## CONSTRUCTION CHANGE AUTHORIZATION

**PROJECT:** City of Franklin, Tennessee  
Franklin WRF Modifications & Expansion Project

**CCA NUMBER:** 003 **CDM SMITH PROJ. NO.:** 14915-231666

**SUBJECT:** Structural Aluminum Stair Support **CITY PROJECT NO.:** 2017-0264

SK-1

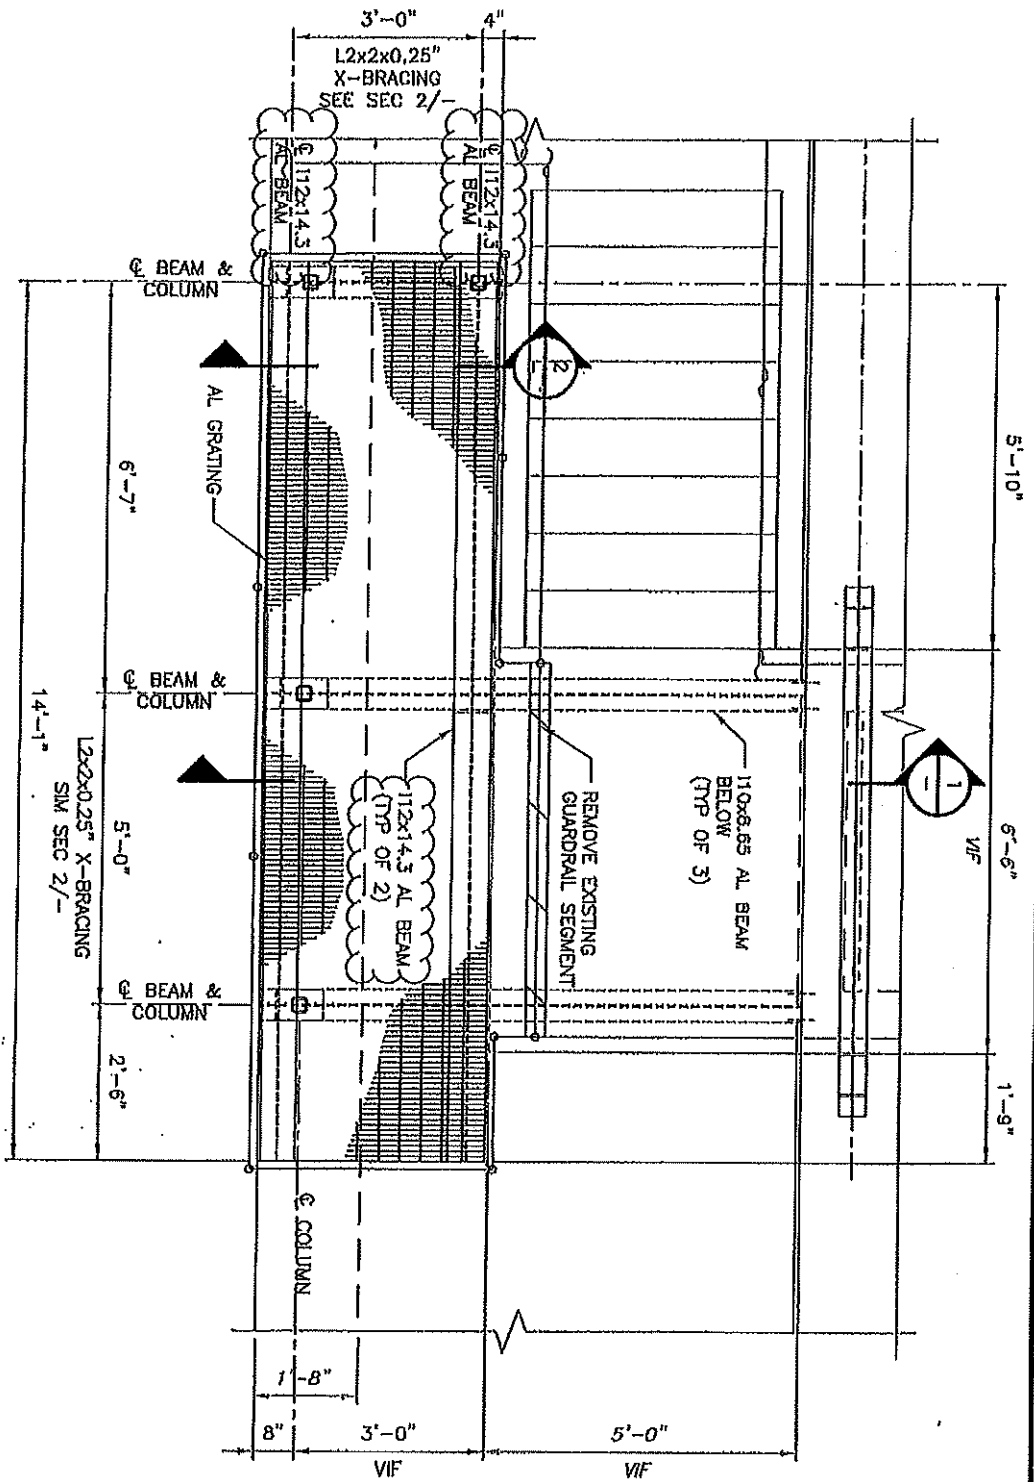
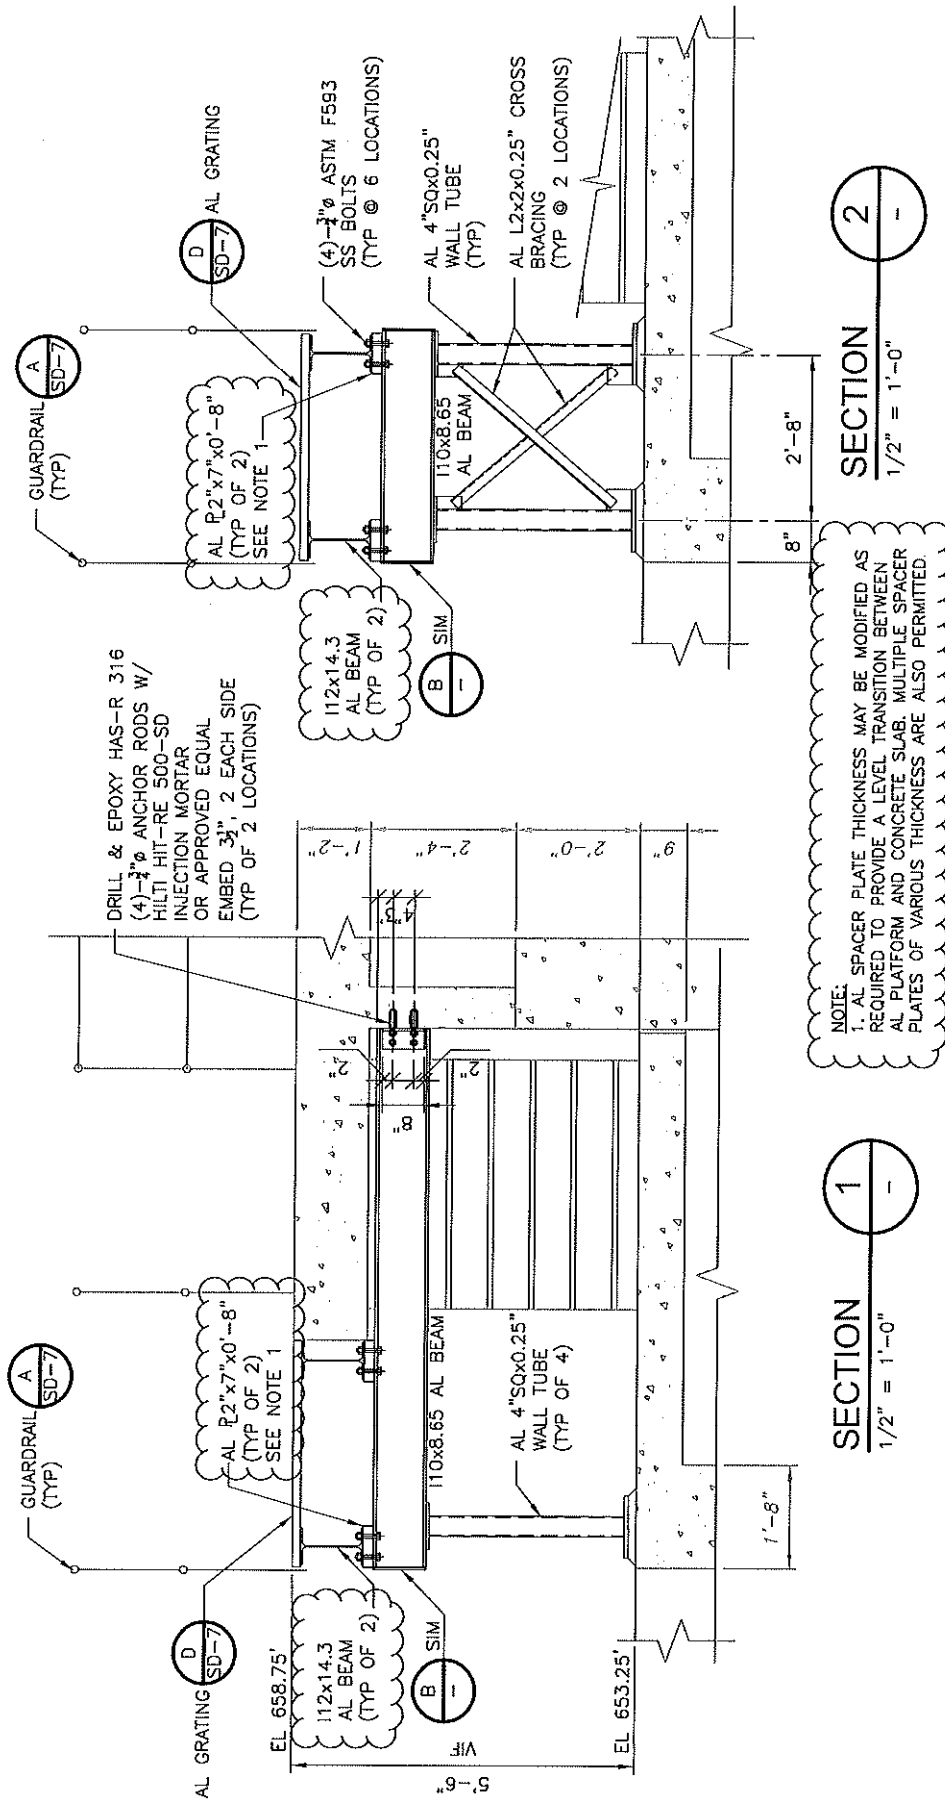
**DESCRIPTION:** At the request of the Contractor per RFI No. 008, item 1, the I14 x 16.0 aluminum support beams shown on Sections 1 and 2, Sh. S-13 may be revised to I12 x 14.3 with spacers per attached Figures SK-1 and SK-2.
